HOWARD COUNTY HISTORIC PRESERVATION COMMISSION
ELlicott CITY HISTORIC DISTRICT ■ LAWYERS HILL HISTORIC DISTRICT
3430 Court House Drive ■ Ellicott City, Maryland 21043

Agenda

Thursday, August 6, 2020; 7:00 p.m.

This Agenda identifies the work proposed and includes comments and recommendations from DPZ Staff. The recommendations included here do not constitute a decision of the Commission.

Figure 8 - Proposed signs

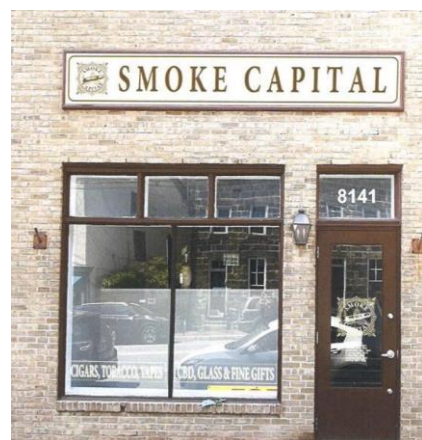
The flat mounted sign complies with Chapter 11.A recommendations. The text will be clear and legible. The colors used in the sign are limited to two, and will be coordinated with the colors in the building façade.

The use of the existing wood sign board complies with the Guidelines, as it is a historically appropriate material.

The proposed flat mounted sign will be located on the existing sign board, which complies with the recommendation to utilize the lines, panels and other architectural details on the building for the placement of signs. Recent businesses have not used this sign board and it has remained a blank, brown rectangle on the front of the building. The Guidelines recommend that more sign area is appropriate for larger buildings along Main Street, and this building is one of the smaller buildings. However, if a smaller sign was placed in the sign board, it would result in an odd proportion that would not be in scale with the building and the sign board. The use of the sign board for a sign that fills it is more visually attractive than leaving the board vacant.

Staff Recommendation to the HPC: Staff recommends the HPC approve Sign #1 and have the HPC determine if an additional sign is appropriate to this storefront.

Figure 15 - Side view of proposed addition from Old Columbia Pike

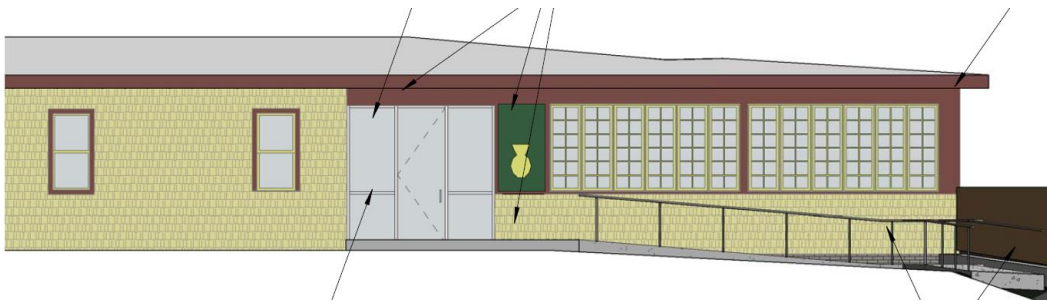
The proposed addition complies with the above Guidelines and will be subordinate to the historic building; it will sit slightly lower than the historic building and will be recessed on the front corner where it attaches to the building. The roof design will run parallel to the historic building, echoing the shape of the original roofline as recommended. The window design on the front of the addition loosely mimics the shape and size of the storefront windows on the first floor.

In general, the paint colors to be used on the addition will match those on the existing building. There is a new design motif being introduced on the addition, and the Commission should determine if it is appropriate for the building.

Staff Recommendation to the HPC: Staff recommends the HPC determine if the painted design motif is appropriate and otherwise recommends the HPC approve the application as submitted.

Figure 19 - Photo taken July 2020. Low brick retaining wall to be removed.

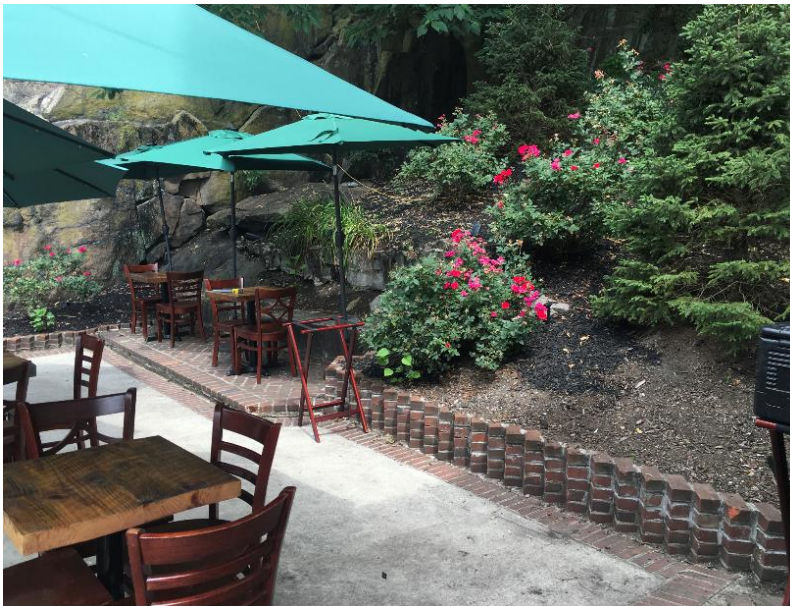
It is unclear what the terrain in this location consists of, and whether it is part of the rock outcropping or mostly soil. The patio will create new sitting area (although it will not be open to the public in the manner of a park, as it will be part of the neighboring restaurant’s outdoor seating).

The Guidelines recommend using appropriate designed retaining walls to create the minimum level area needed for a new use. The proposed 5-foot tall retaining wall, to be topped by a 3.5 foot tall fence, does not seem appropriately designed as it will create a large vertical surface that does not currently exist. A lower retaining wall, if possible, would create a more human scaled environment.

Staff Recommendation to the HPC: Staff recommends the HPC determine if the new wall and patio comply with the Guidelines and approve, deny or modify accordingly. If the wall is approved, Staff recommend the HPC approve the proposed fence, which complies with the Guidelines.

Figure 23 – Faux painting approved in July 2020.

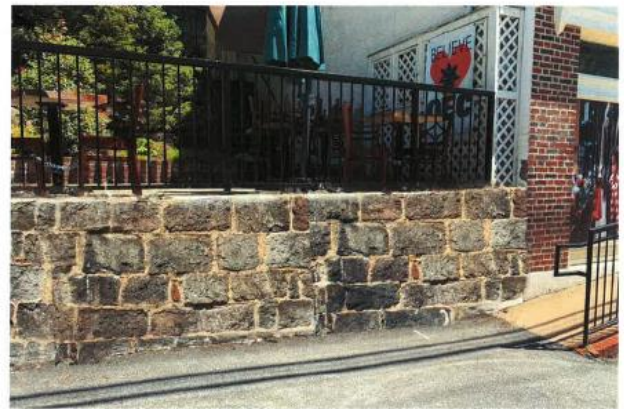
At the July 2020 meeting, in case HPC-20-53, the Commission approved the faux painting of a granite wall scene on the existing parged retaining wall adjacent to the sidewalk. The current application for the construction of the 5-foot retaining wall states the wall will be gray to match that typically found in Ellicott City, but does not contain a sample of the actual color variations, stone size or mortar color. It is unknown what the proposed new wall would look like in conjunction with the approved faux granite painting on the existing wall. A stone sample board would be helpful to see what the rock courses would look like. This application should have been submitted along with the mural so that the HPC would have a full understanding of the desired changes for this area, rather than piecemeal applications. The proposed bluestone tiles, which will not be visible from the street, comply with the Guidelines and will be compatible with the historic building and neighboring rock outcropping.
